**COMMITTEE OF ADJUSTMENT
SUMMARY OF COMMENTS FOR MAY 17, 2023
FOR APPLICATION A08-23
51 CLIFFORD STREET**

TO: Committee of Adjustment – Meeting of May 17, 2023
FROM: Planning Division
DATE: May 5, 2023
FILE NO: Application for Minor Variance A08-23
APPLICANT: Innovative Planning Solutions (c/o Tyler Kawall)
OWNER: MDR Group Inc. (c/o Steve Reddick)
**SUBJECT
PROPERTY:** 51 Clifford Street- Minor Variance

Angular Planes

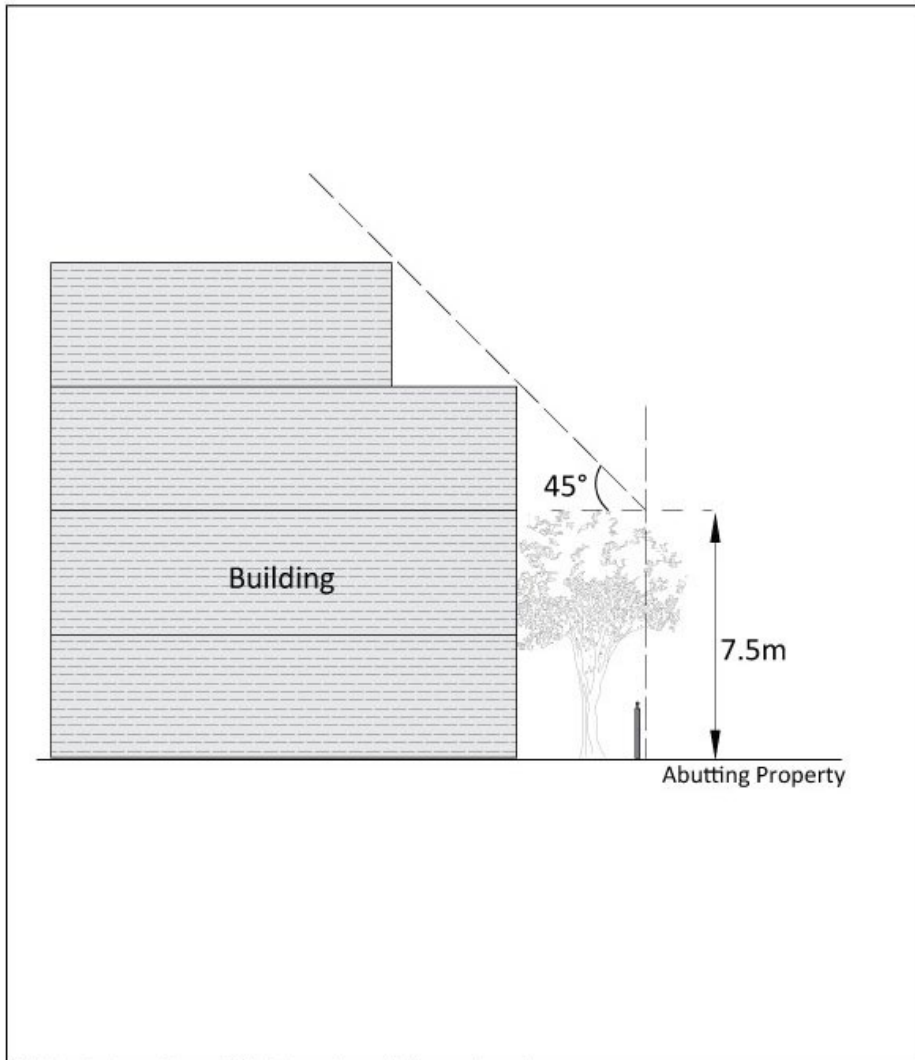
<p>On the matter of Height <input checked="" type="checkbox"/> Yes <input type="checkbox"/> No <input type="checkbox"/> Defer</p> <p>On the matter of the 0.5m setback <input type="checkbox"/> Yes <input type="checkbox"/> No <input checked="" type="checkbox"/> Defer</p>	<p>The Intent and purpose of the “Intensification Area” is to identify lands where intensified development should. The 'Intensification Area' should provide opportunities for transit supportive and mixed-use proposals to thrive, which includes proximity to public transit routes and local conveniences. Orchard Point, being entirely comprised of local road networks, will never have this ability and currently transit is only in place up to and up to the Invermera development, with no sidewalk connections in place to get there. The local convenience is in proximity, but options to get there involve crossing the unsignalized provincial highways corridor, therefore making the reliance on a vehicle necessary for those living on Orchard Point. As a result, the increased vehicles and trip have staff worried about how much more density the existing infrastructure can support. Unfortunately, due to the introduction of Bill 23 Site Plan Control can no longer be applied to development proposing less than 10 dwelling units, which would have given the City opportunity to request Traffic Impact Studies. If the development requires additional approval under the <i>Planning Act</i>, such as Plan of Condominium, this would be an opportunity to request such studies.</p> <p>Staff recognize that within the “Intensification Area” designation Apartment Buildings are permitted uses and “Single Detached Dwelling”, with lower densities are considered prohibited uses. Under applicable policy, lands are permitted to realize no lower than 2 storeys and no higher than 8 storeys, and where the proposed development is proposing 4 storeys, so it is inline with this direction. However, where such heights abut a Stable Neighbourhood or Downtown Shoulder Designation, Angular Planes shall be used. Staff feel given the contrast of the area that the utilization of Angular Planes for this development is suitable, since reviews have begun to reassess the validity of the Intensification Designation for this area.</p> <p>Further to this section 3.3.7.4.1 g) of the “Intensification Area” stipulates that all new development will be compatible with adjacent and neighbouring development by ensuring that the siting and massing of new buildings does not result in undue, adverse impacts on adjacent properties particularly in regard to adequate privacy conditions for residential buildings and their outdoor amenity areas. Angular Planes will require that the upper stories of the development (anything higher than 3 storeys) will be stepped back in order not to crowd adjacent developments. The City’s Zoning By-law provides an illustration of how Angular Planes would be applied in a situation like this.</p>

Staff would suggest that as a condition of approval of the height that Angular Planes be utilized. Therefore, staff are supportive of the increase in height and density provided the conditions of approval are completed prior to commencement of construction

1. That the Owner/Applicant apply the provision of “Angular Planes “as set out in section 5.3 of Zoning By-law 2014-44, as amended to the existing lower density single detached dwelling unit which flanks the northern property line.
2. That the Owner/Applicant provide a cost estimate for the cost of erecting of a 2.0m privacy fence around the perimeter of the property, and deposit the amount outlined in that cost estimate in advance of applying for a building permit. Once proof of or inspection of the erected fence is provided to the City then the Owner/Applicant shall receive their deposit back.
